**WAUSEON EXEMPTED VILLAGE SCHOOLS**  
**New Administration Office Building**  
Wauseon, Ohio

B7-4551

**ADDENDUM NO. 1**

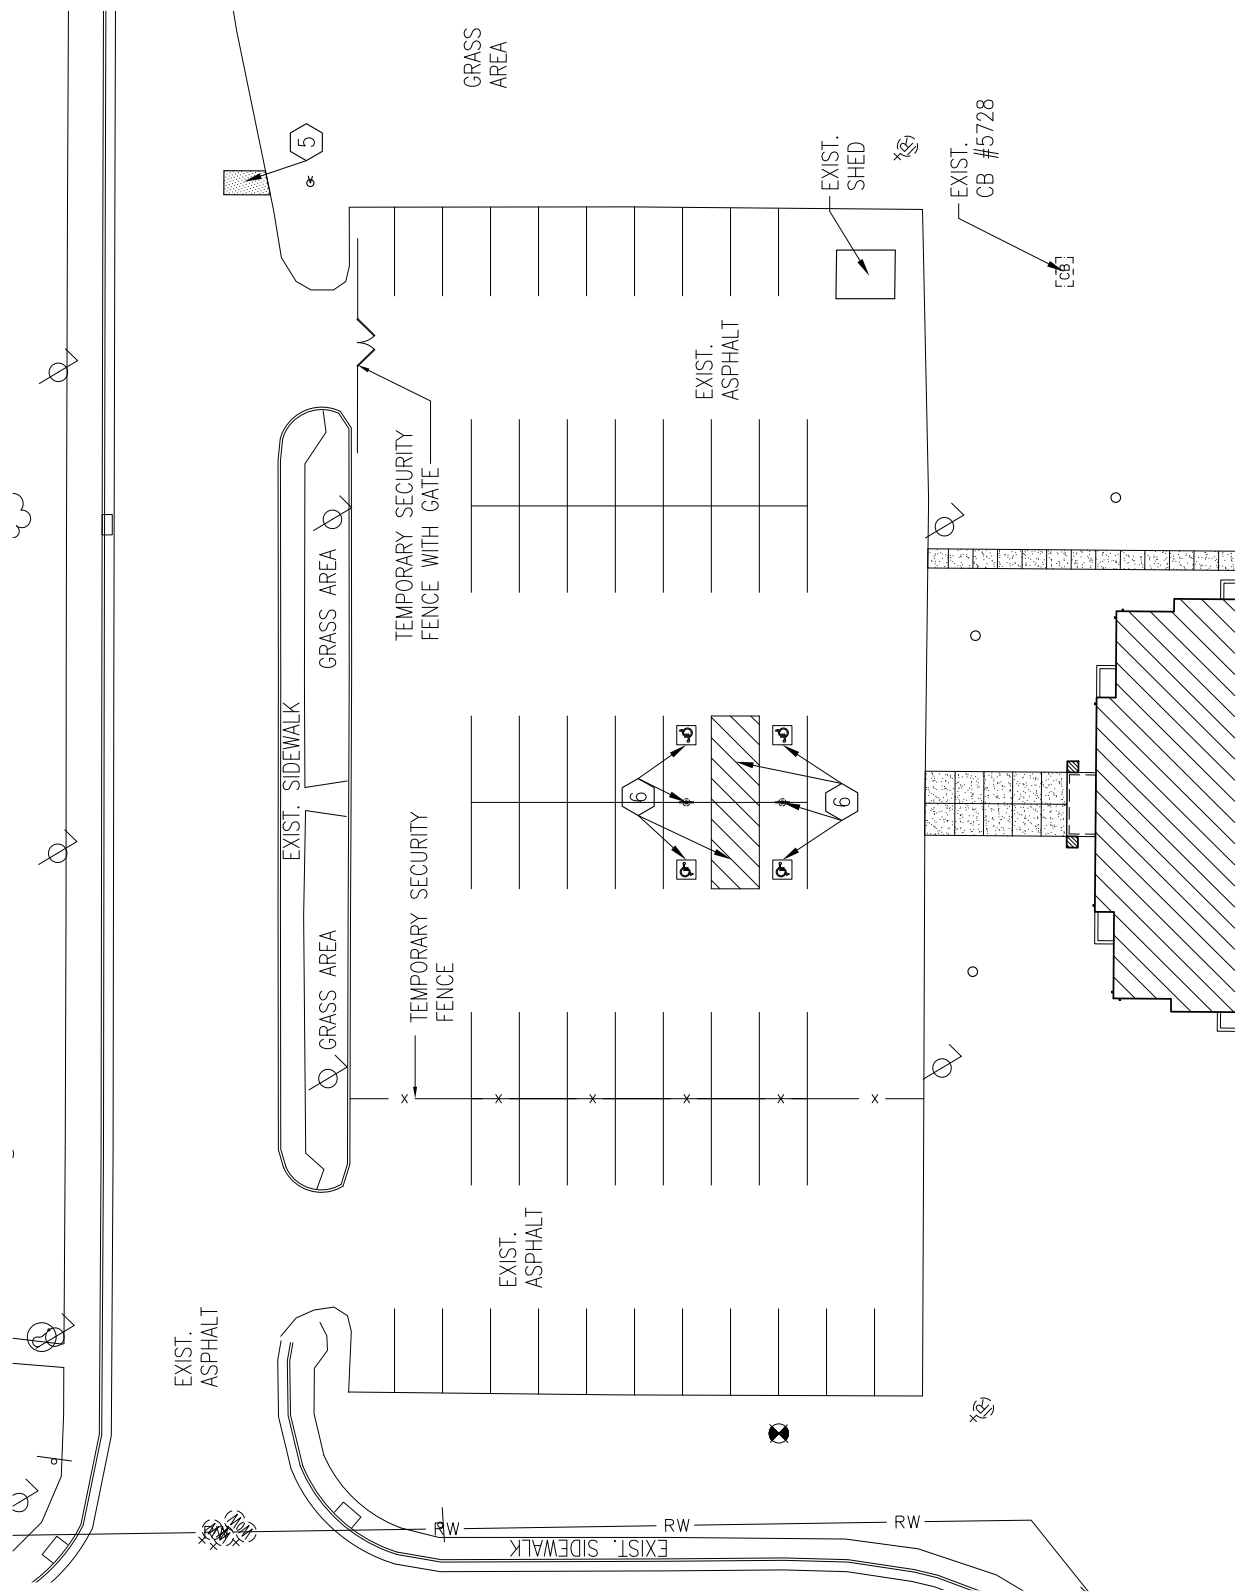
Alternate Foundation Wall Detail 8 and Typical Foundation Wall Detail 9: Refer to attached Addendum Drawing SF101a for revised details.

# STOREFRONT/WINDOW ELEVATIONS

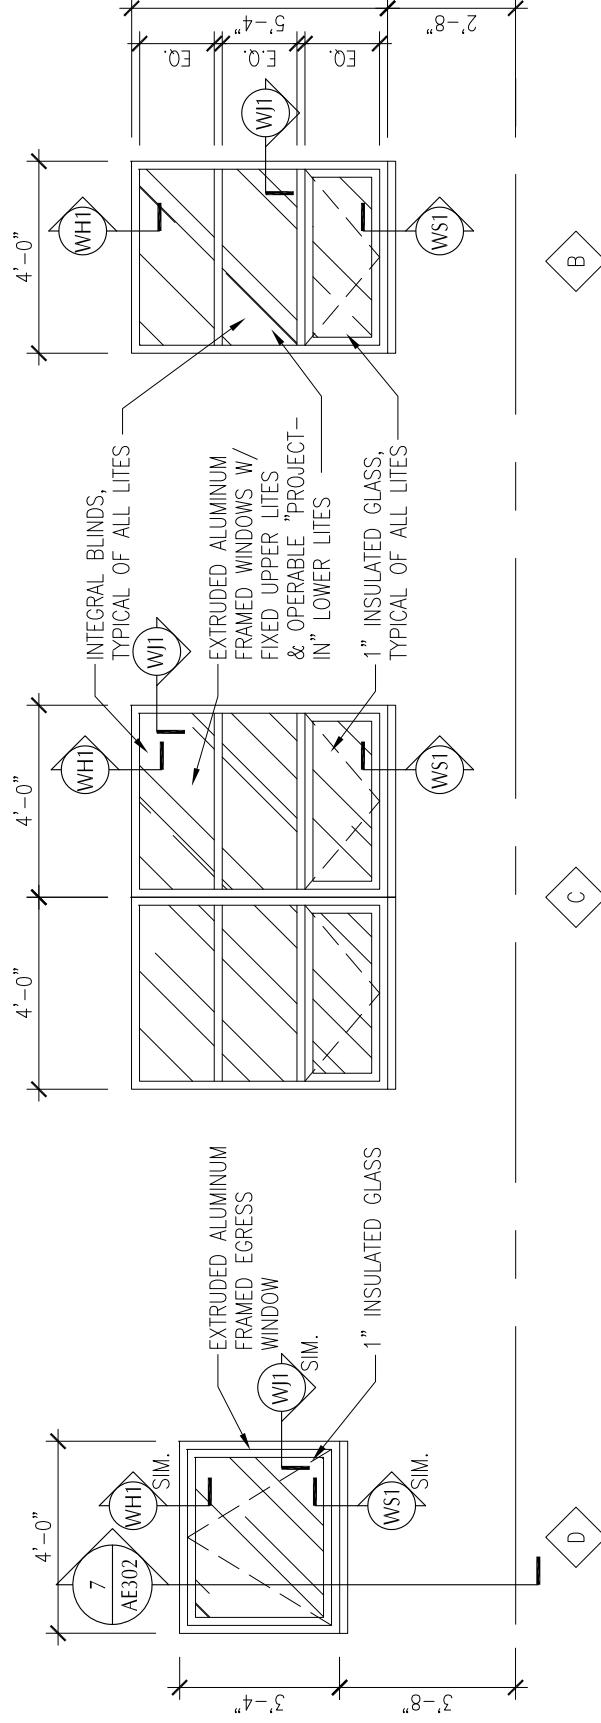
Storefront/Window Elevations: Refer to attached Addendum Drawing AE601a for revised windows B, C, and D.
